Rule: ~~2010-016-115-EN~~ **Corrected Rule Reference 2010-025-115-EN**

- a) Chapter 115 VOC Storage Tank Rule Amendments
Rule Project No. 2010-025-115-EN
- b) Chapter 115 CTG RACT Rule Amendments
Rule Project No. 2010-016-115-EN
- c) DFW SIP Attainment Demonstration Revision (including photochemical modeling, weight of evidence, RACT, RACM, an MVEB, and a contingency plan) Rule Project No. 2010-022-SIP-NR
- d) DFW SIP Reasonable Further Progress Revision
Rule Project No. 2010-023-SIP-NR
- e) HGB RACT Analysis Update SIP Revision
Rule Project No. 2010-028-SIP-NR
- f) DFW Attainment Demonstration and Reasonable Further Progress (RFP) SIP Revision Supplements

Figure 1. VOC Emission Factor as a Function of Condensate Production, Excluding Tank Battery 26
(Derived from HARC H51C Report)

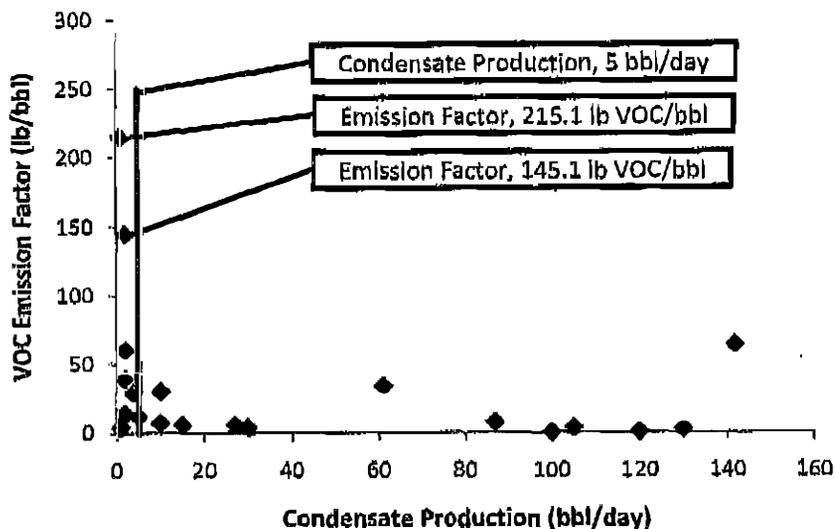
Derived tank battery-specific VOC emission factors ranged from 0.7 lb/bbl to 215.1 lb/bbl. Figure 1 presents the relationship between condensate production and estimated VOC emission factor for the 21 condensate storage tank batteries used by URS in the derivation of the VOC emissions as a function of condensate production emission factor.

For this data set, the mean VOC emission factor was 33.3 lb/bbl with a standard deviation of 53.3 lb/bbl.⁵ As can be seen from Figure 1, there are two sites with much higher VOC emission factors compared to the other sites. These two sites are denoted with red diamonds. The emission factors and condensate production rates for these two sites are:

Figure 2. Box-and-Whisker Plot for All Data Points Used in Deriving 33.3 lb/bbl Emission Factor
(Derived from HARC H51C Report)

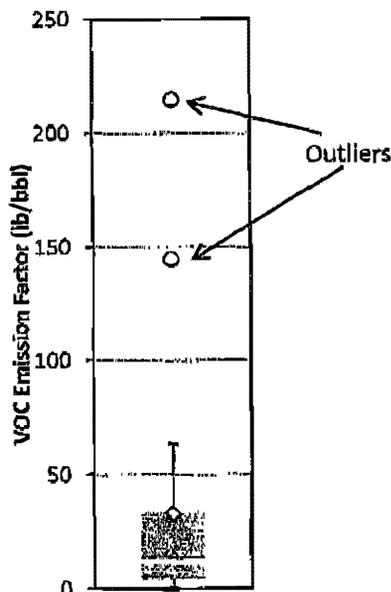
The two red circles in Figure 2 representing 215.1 lb VOC/bbl and 145.1 lb VOC/bbl emission factors for Tank Batteries 25 and 17, respectively, are outside outliers and, most likely, should be excluded from the analysis.

If the outside outliers identified in Figure 2 are excluded from the data set, the average VOC emission factor is 17.9 lb/bbl with a standard deviation of 19.5 lb /bbl. By excluding these two outliers, the standard deviation becomes smaller relative to the mean: 1.1 times the mean versus 1.6 times the mean when these two data points are not excluded. Therefore, the data shows better agreement when these two data points are excluded.

Figure 3. VOC Emission Factor as a Function of Condensate Production, Tank Batteries with Production \geq 5 bbl/day
(Derived from HARC H51C Report)

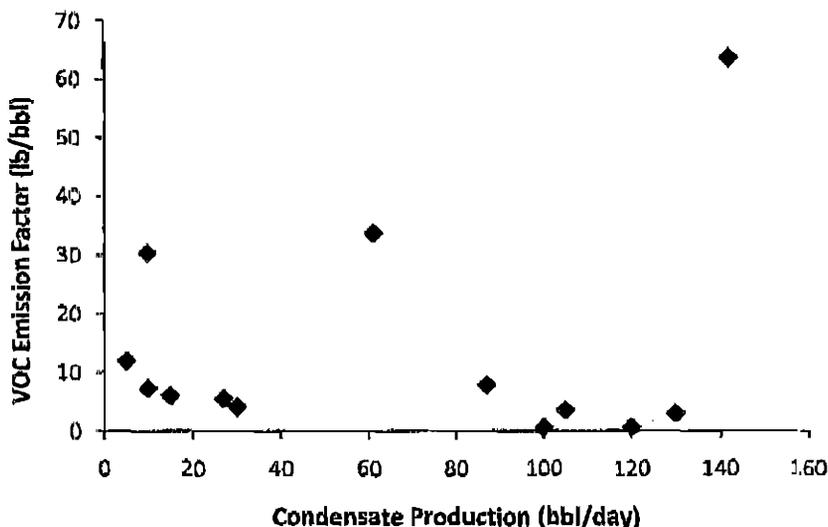
The mean VOC emission factor for this data set is 13.8 lb VOC/bbl with a standard deviation of 18.3 lb VOC/bbl (1.3 times the mean). While showing less variability than the data set presented in Figure 1, the data shown in Figure 3 does demonstrate variability due to the three points shown as red diamonds.

Figure 4. Box-and-Whisker Plot for Derived VOC Emission Factors, Tank Batteries with Production \geq 5 bbl/day
(Derived from HARC H51C Report)

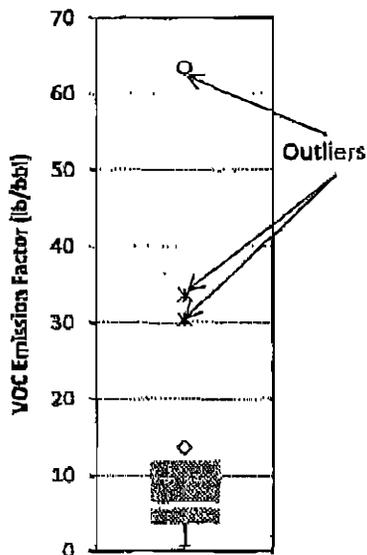
Figure 4 is a box-and-whisker plot for derived VOC emission factors for 13 tank battery sites with condensate production greater than or equal to 5 bbl/day. As explained earlier in this summary, the box-and-whisker plot is a useful way of identifying outliers. The red circle in Figure 4 is an outside outlier. This represents the derived VOC emission factor for Tank Battery 32. The red stars in Figure 4 are inside outliers. The two stars represent the derived VOC emission factors for Tank Batteries 20 and 29.

If the one site identified as an outside outlier in Figure 4 is excluded from the data set, the average VOC emission factor is 9.6 lb/bbl with a standard deviation of 11.0 lb /bbl. By excluding this one data point, the standard deviation becomes smaller relative to the mean: 1.1 times the mean versus 1.3 times the mean when this data point is not excluded. Therefore, the data shows better agreement when this data point is excluded.
